CALVERT CLIFFS NUCLEAR POWER PLANT, UNIT 1

AMENDMENT TO FACILITY OPERATING LICENSE

Amendment No. 130  
License No. DPR-53

ATTACHMENT TO LICENSE AMENDMENT

TIME IN CYCLE  
Figure 3.1-1b

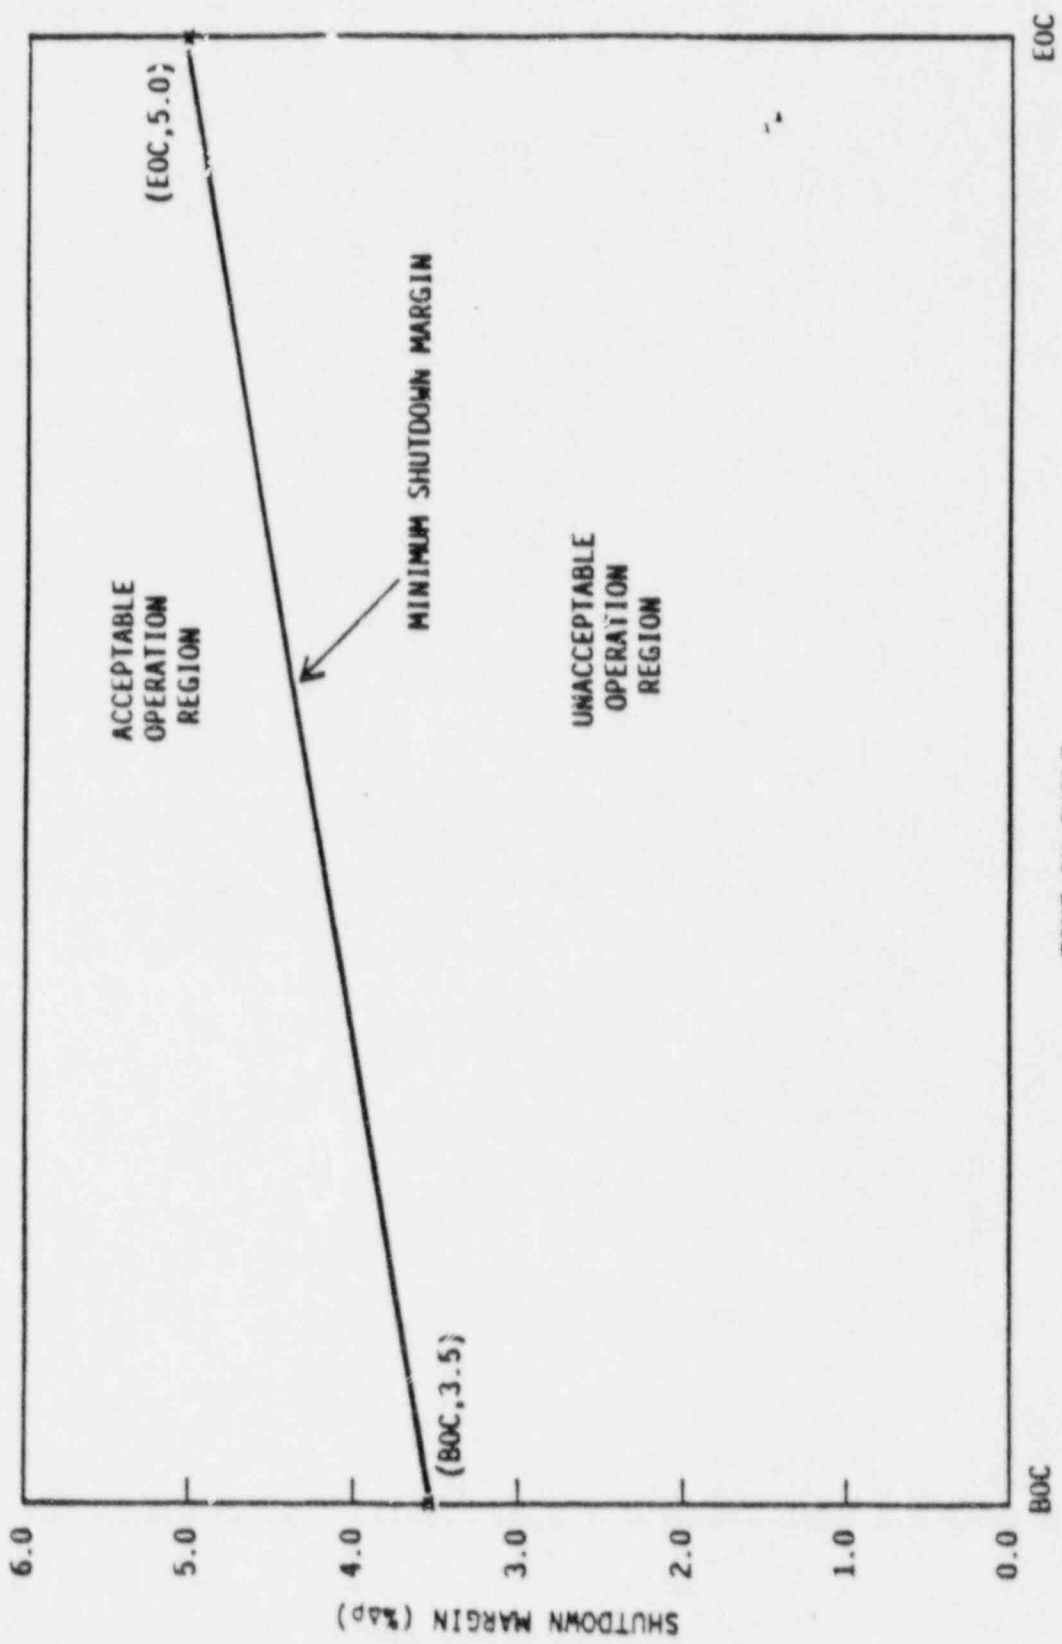
3.1.1.1 The SHUTDOWN MARGIN shall be equal to or greater than the limit line of Figure 3.1-1b.

With the SHUTDOWN MARGIN less than the limit line of Figure 3.1-1b immediately initiate and continue boration at  $\geq 40$  gpm of 2300 ppm boric acid solution or equivalent until the required SHUTDOWN MARGIN is restored.

4.1.1.1.1 The SHUTDOWN MARGIN shall be determined to be equal to or greater than the limit of Figure 3.1-1b:

FIGURE 3.1-1a

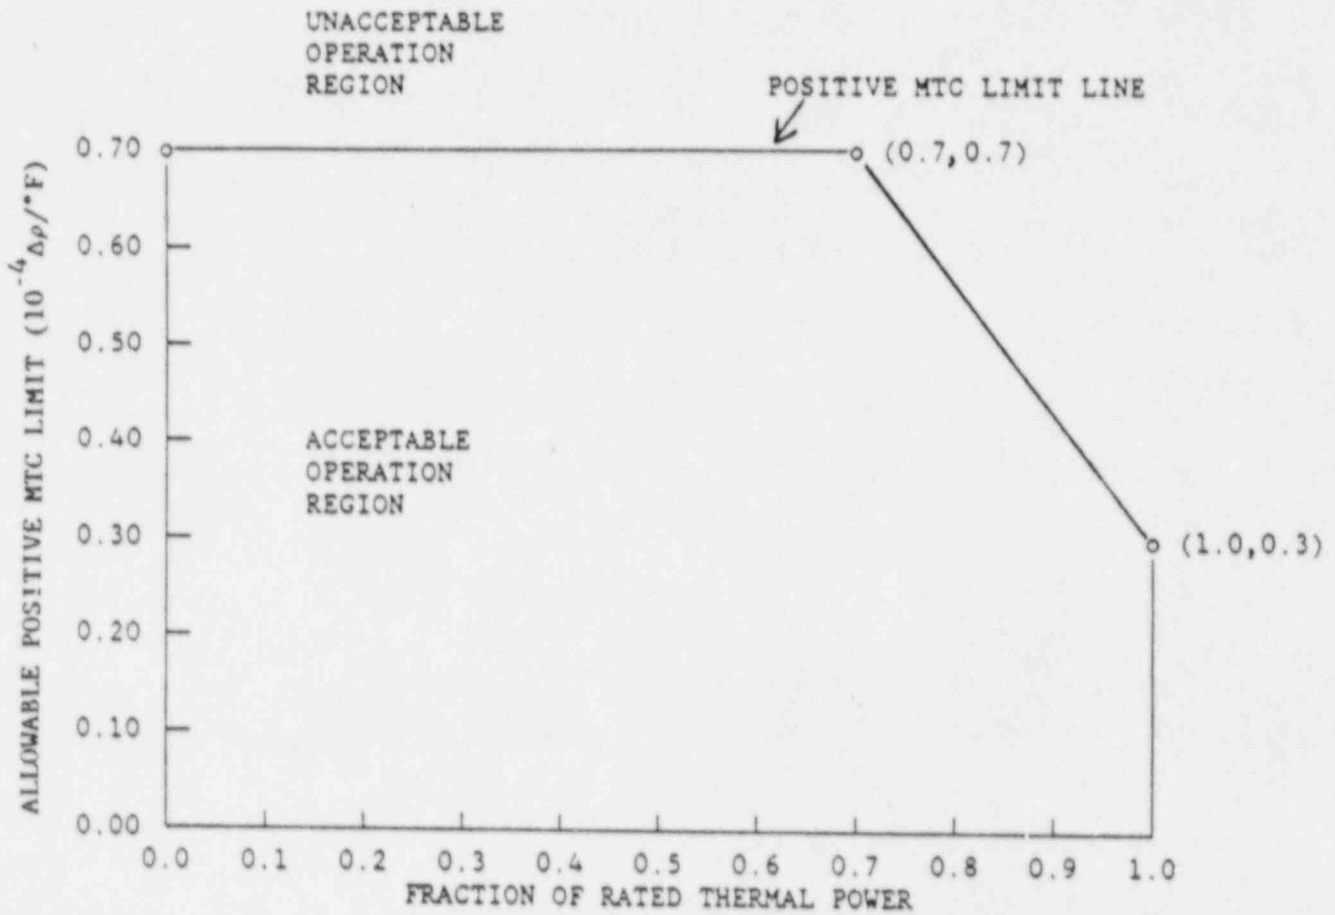
- a. Less positive than the limit line of Figure 3.1-1a, and
- b. Less negative than  $-2.7 \times 10^{-4} \Delta k/k/^{\circ}F$  at RATED THERMAL POWER.
